PILATUS AIRCRAFT LTD, STANS, SWITZERLAND

Service Bulletin No: 21-016 Ref No: 449

Modification No: EC-22-0287 **ATA Chapter:** 21

AIR CONDITIONING - COMPRESSOR CONDENSER MODULE MODIFICATION TO THE COMPRESSOR/CONDENSER BONDING

VCCS Compressor - Modification Figure 1 (Sheet 1 of 1)

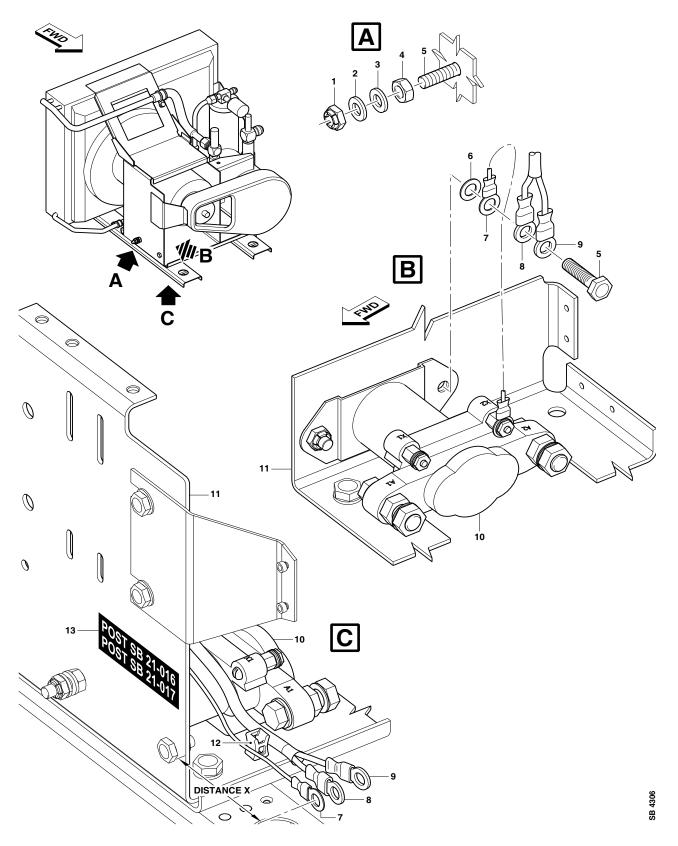
- (1)Disconnect the compressor/condenser power return cables (8) and (9), and the relay return cable (7) from the relay (10), as follows. Refer to Figure 1:

- Remove the two nuts (1 and 4) and the two washers (2) and (3) from the bolt (5). (a)
 - (b) Remove the bolt (5) and the washer (6) and disconnect the two black motor return wires (8) and (9) and the relay return wire (7) from the inside of the compressor/ condenser chassis (11) and the relay (10).

- Carefully pull the two black motor return wires (8) and (9) and the relay return wire (g) (7) forward, from the inside of the compressor/condenser chassis (11) and over the relay (10).

- Make sure distance X is more than 20mm. (h)
 - Install the harness spacer (P/N 971.32.18.106) (12) with cable ties (Material No (i) P09-005, P09-008, P09-014) between the two black motor return wires (8) and (9) and the relay return wire (7).

- (j) Install the new SB 21-016 placard (P/N 511.30.12.109) (13) on the chassis (11) as follows:

- (f) Make sure that the relay return wire (7), the two black motor return wires (8) and (9) do not touch the relay (10). Refer to Figure 1, view C.
 - (g) Use a bonding tester (Local supply) to do a bonding check between the ground stud nut (35) and the aircraft structure, refer to Figure 3. The maximum resistance is $2.5 m\Omega$.

VCCS Compressor - Structural bonding modification Figure 2 (Sheet 1 of 1)

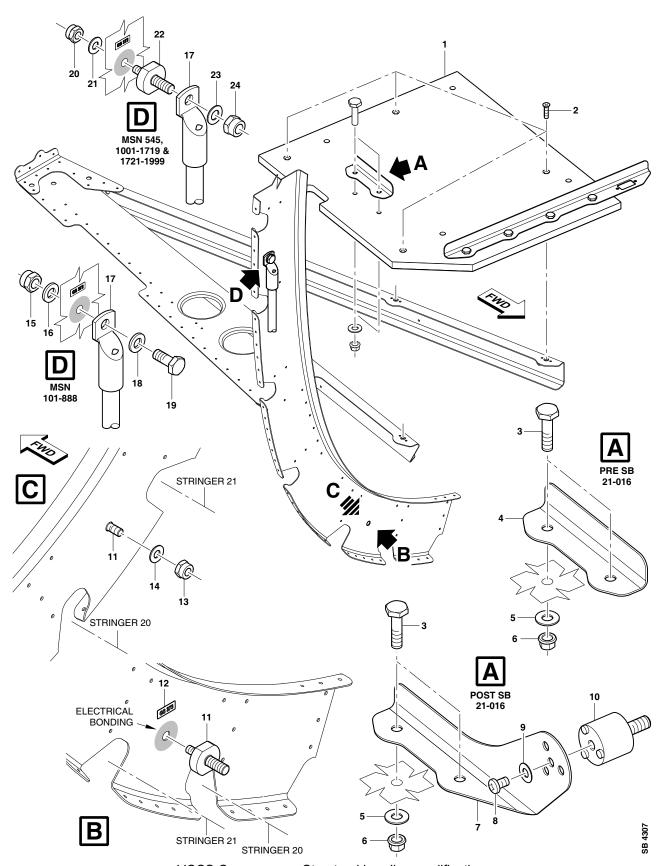
- (1) Inspect the compressor/condenser power return/chassis grounding cable (17) and the attachment point at frame 37 (GS 372), refer to Figure 2, view D, for:
 - · Security of attachment
 - · Correct sealing.
- (2) Remove and retain the grounding cable (17) from GS 372 as follows, refer to Figure 2, view D:
 - (a) If necessary, remove the sealant from the GS 372.
 - (b) Remove the nut (15), the two washers (16) and (18) from the bolt (19).
 - (c) Disconnect the bonding lead (17) from the GS 372.

- (5) Remove the composite base plate (1) as follows, refer to Figure 2:
 - (a) Remove and retain the four bolts (2) from the structure and the composite base plate (1).

- (4) Apply a layer of Adhesive (Material No. P08-017) to the threads of the screw (P/N 931.54.41.728) (8). Refer to Figure 2.
- (5) Install the isolated attachment bolt (P/N 974.03.38.192) (10) on the stop angle (7) with the screw (8) and the washer (P/N 938.77.11.110) (9). Refer to Figure 2.

- (6) Install the new ground stud (GS 373) (P/N 591.30.12.030) (11) on frame 37 between stringers 20 and 21, as follows. Refer to Figure 2:
 - (a) At GS 373 use an abrasive pad (Material No. P02-016) to remove the primer to a diameter of 25.4 mm (1 in), refer to Figure 2, view B.

- (d) Let the CCC dry.
 - (e) Apply a layer of sealant, electrically-conductive (Material No. P08-070) to the mating surfaces of the GS 373 (11) and frame 37.

- (f) Install the GS 373 (11) on frame 37 with the washer (P/N 938.77.11.112) (14) and the nut (P/N 938.07.68.304) (13).
 - (g) Install the new GS 373 placard (P/N 511.36.12.647) (12) on the FWD side of frame 37 as follows:

- (h) Apply CPC (Material No. P10-013) to the nut (13) and the threads of the GS 373 (11) on the aft side of frame 37.
- (7) Install the bonding lead (17) on GS 372 as follows, refer to Figure 2, view D:

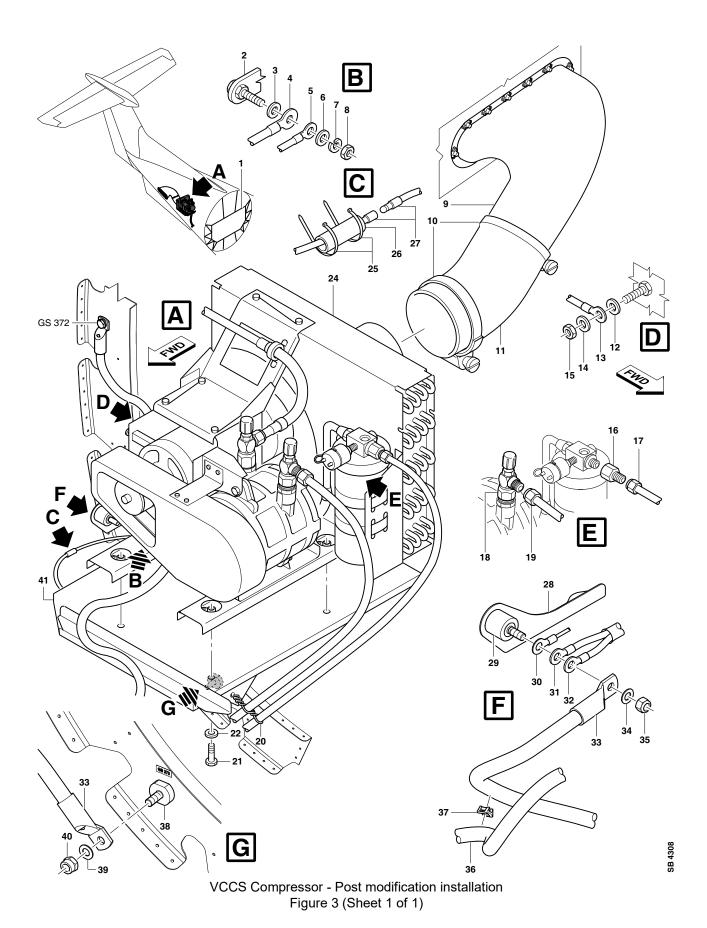
- (8) Install the composite base plate (1) as follows, refer to Figure 2:
 - (a) Clean the installation area with absorbent paper (Material No. P02-031) made moist with solvent (Material No. P01-010).
 - (b) Put the composite base plate (1) in position.
 - (c) Install the composite base plate (1) with the four screws (2).
- Install the compressor/condenser unit as follows. Refer to Figure 3: (9)

- Carefully put the compressor/condenser unit (24) on the composite base plate (41). (a)
- (b) Attach the compressor/condenser unit (24) to the composite base plate (41) with the four bolts (21) and four washers (22).

- (10) Install the relay return wire (30), the two black motor return wires (31) and (32), and the new bonding strap (P/N 521.51.12.012) (33) as follows. Refer to Figure 1 and Figure 3:

- (a) Connect the relay return wire (30), the two black motor return wires (31) and (32), and the new grounding cable (33) to the isolated ground stud (29) on the stop angle (28), refer to Figure 3.

- (d) Connect the new bonding strap (33) to the new GS 373 (38) with the washer (P/N 938.77.11.114) (39) and the nut (P/N 938.07.68.305) (40).
 - (e) Secure the bonding strap (33) to the adjacent wire (36) with the cable spacer (P/N 971.32.18.108) (37) and cable ties (Material No P09-005, P09-008, P09-014).

- (h) Apply a layer of CPC (Material No. P10-013) to the attachment fittings of the compressor/condenser unit grounding point and the isolated ground stud (29). Refer to Figure 3, views D and F.
